## PLANNING AND DEVELOPMENT SERVICES STAFF REPORT

For Planning Commission Meeting of December 18, 2012

**SUBJECT: 544 Detroit Planned Project Site Plan for City Council Approval  
(544 Detroit Street)  
File No. SP12-032**

REVISIONS	CITY OF ANN ARBOR
DECEMBER 13, 2012	CITY OF ANN ARBOR
NOVEMBER 21, 2012	PERMITTING
DECEMBER 10, 2012	CITY OF ANN ARBOR
DATE	PERMITTING
OCTOBER 29, 2012	PERMITTING
SCALE	0 5 10 1"=10'
DR. GFD	Ch. K.K.
BOOK	
FILE NO.	
SHEET NO.	SP-03

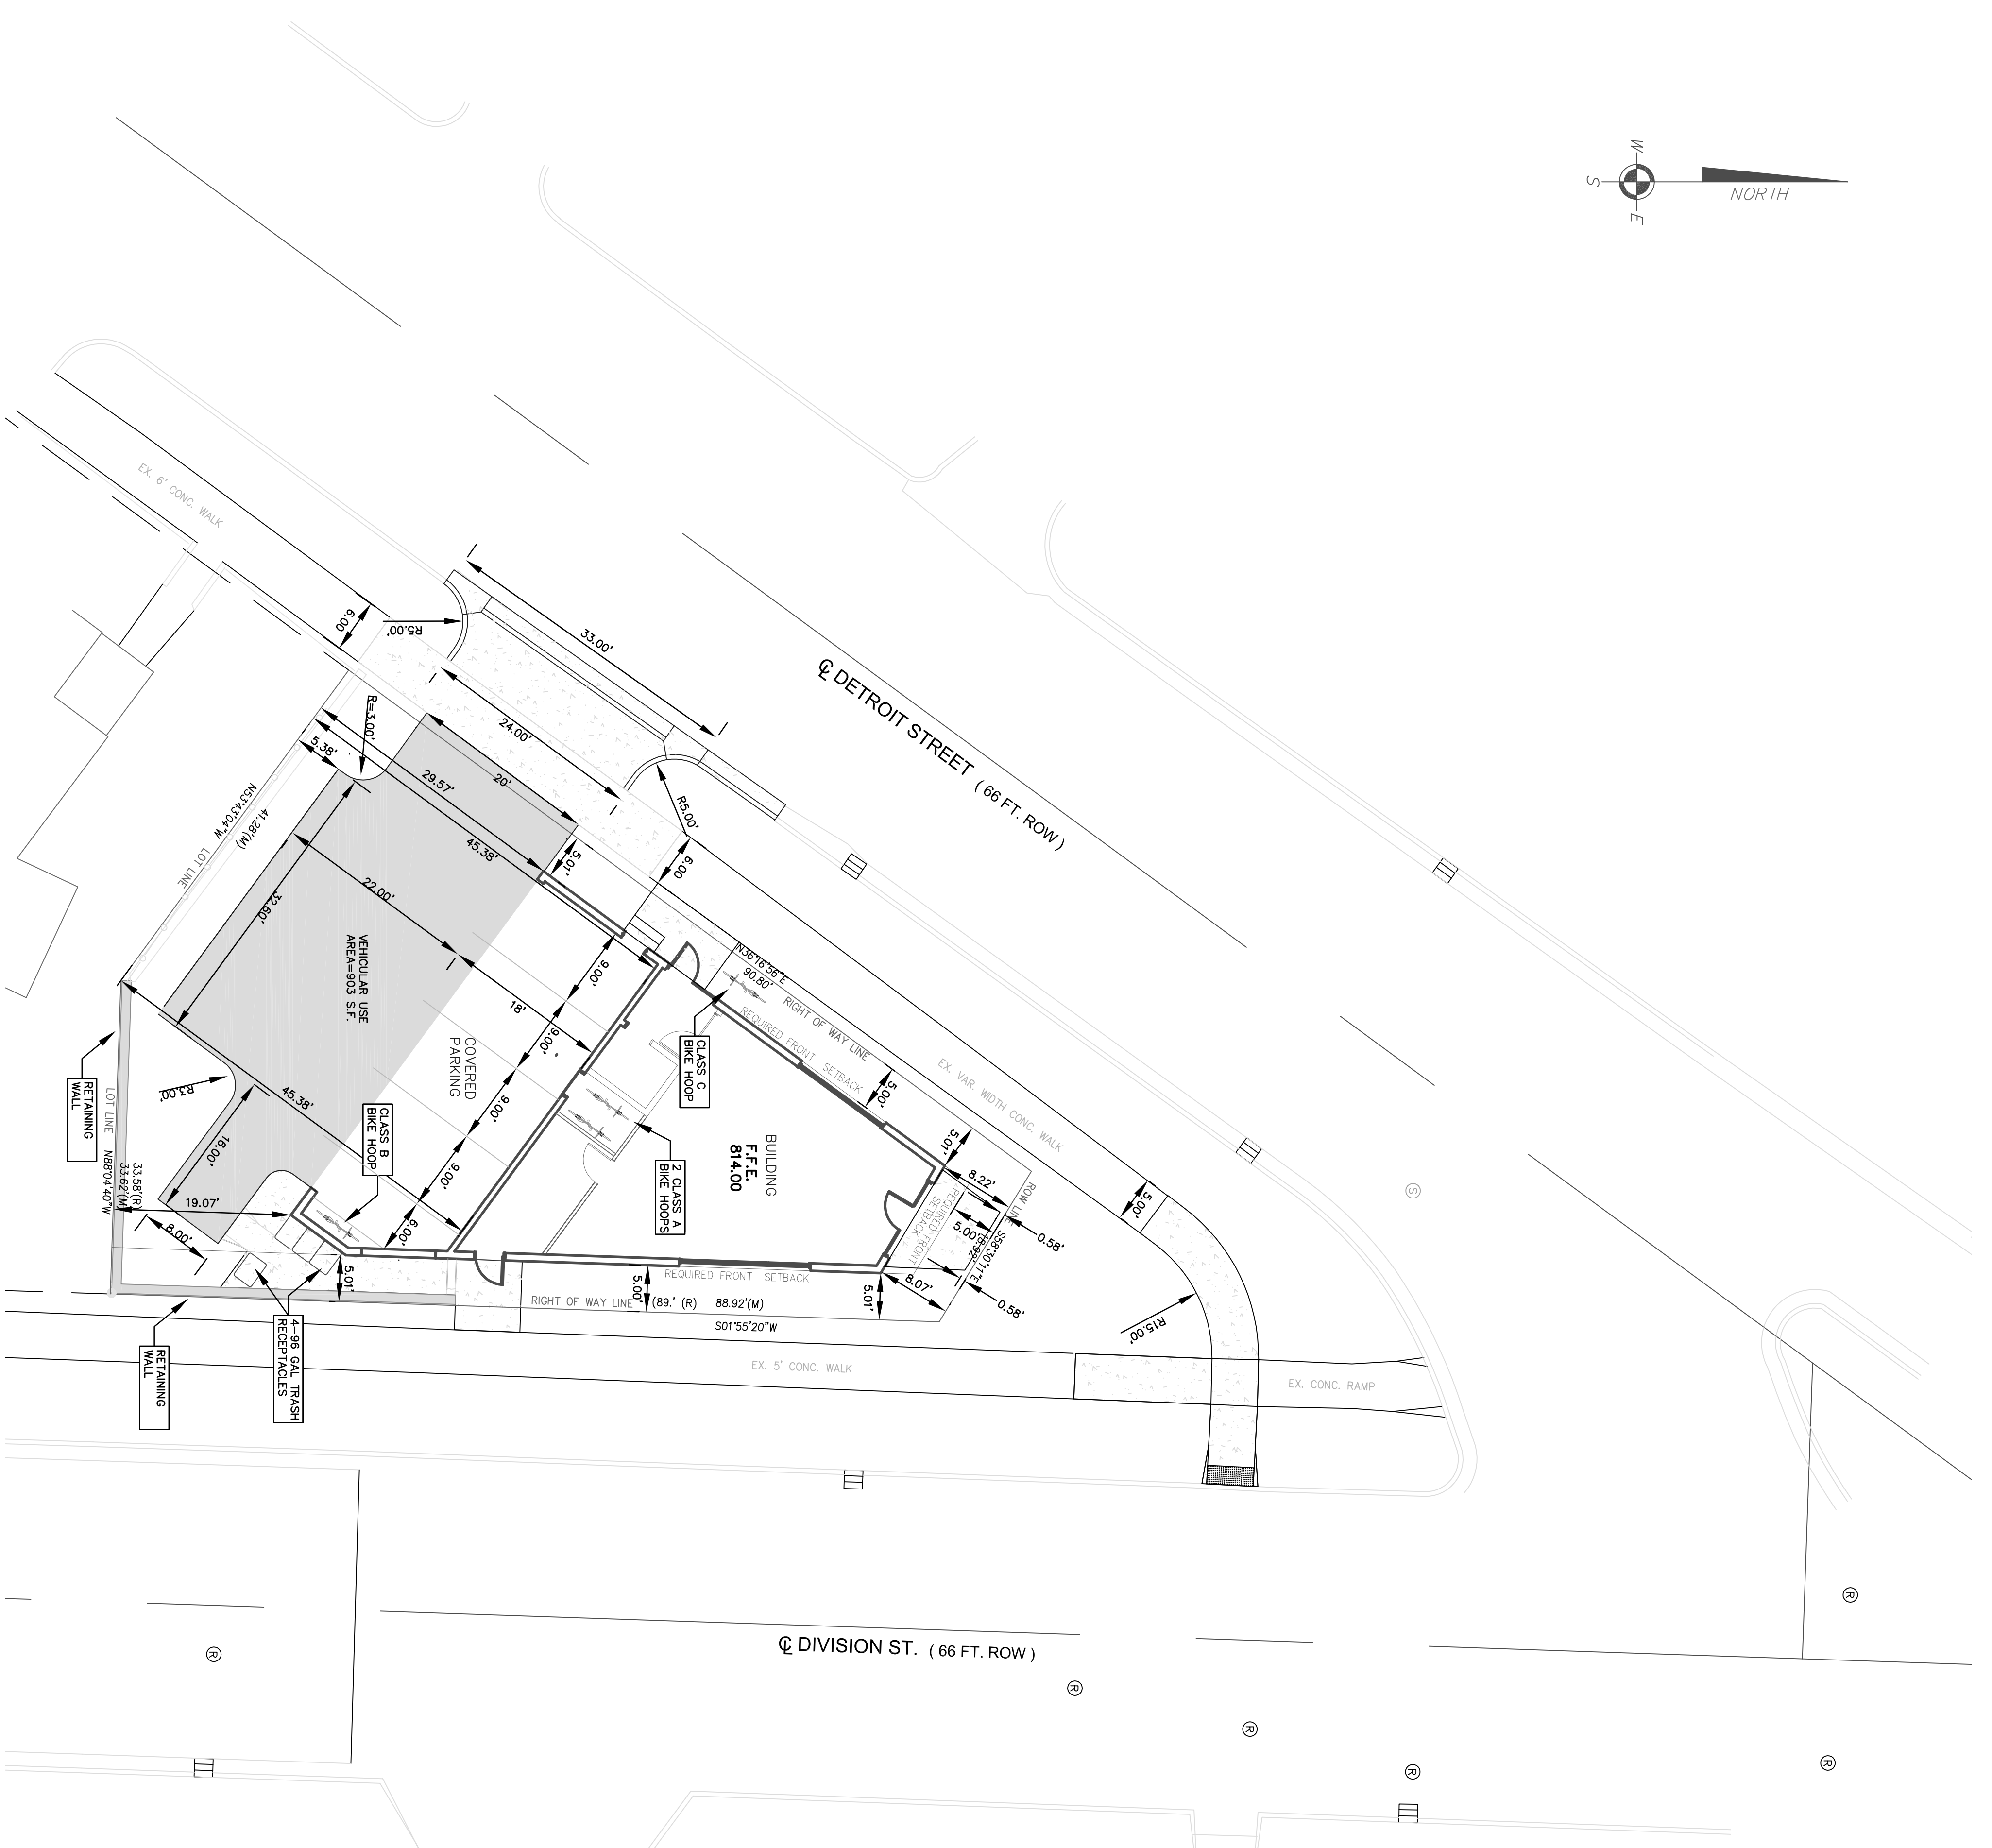
*The layout plan indicates a rear setback of 19 feet at its narrowest point.*

LANDSCAPING  
sheet

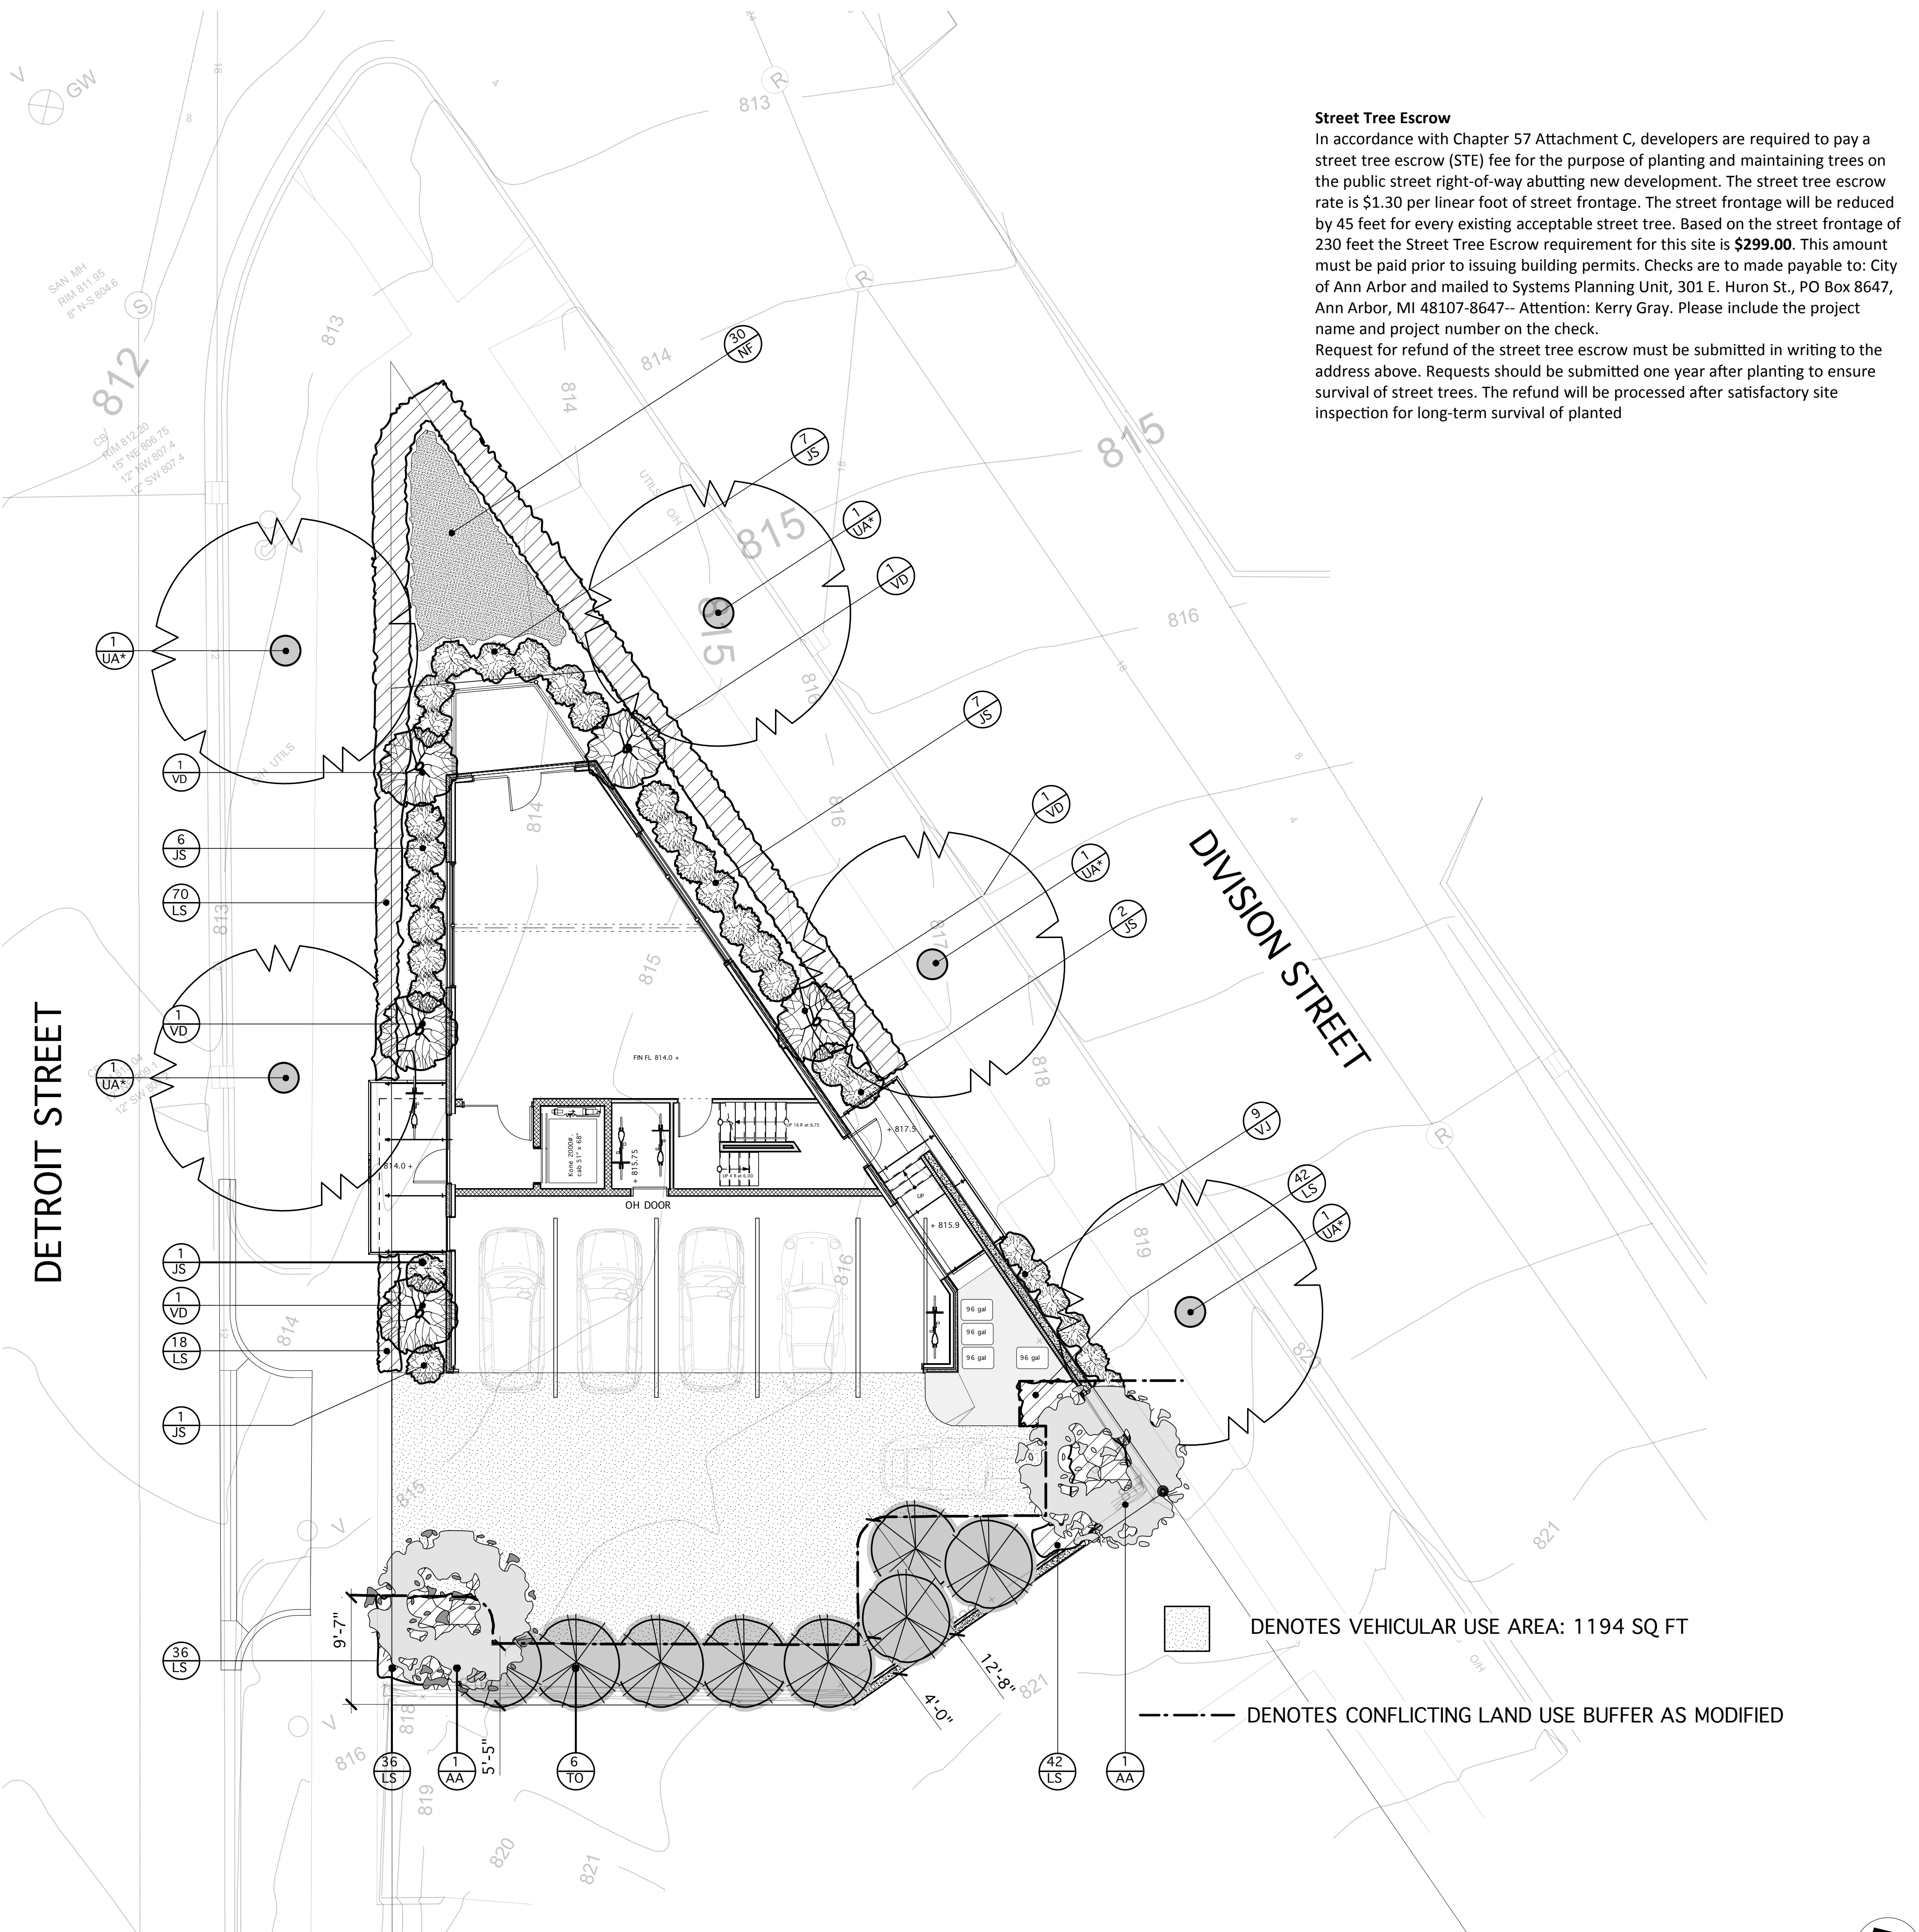
*The Urban Forest Coordinator in Systems Planning comments: Staff disagrees with this statement; the CLUB [conflicting land use buffer] requirements in Chapter 62 are to provide a buffer between conflicting land uses and zoning districts, regardless of project size. There are no references in Chapter 62 regarding the "intention" of the CLUB based on the size of the project.*
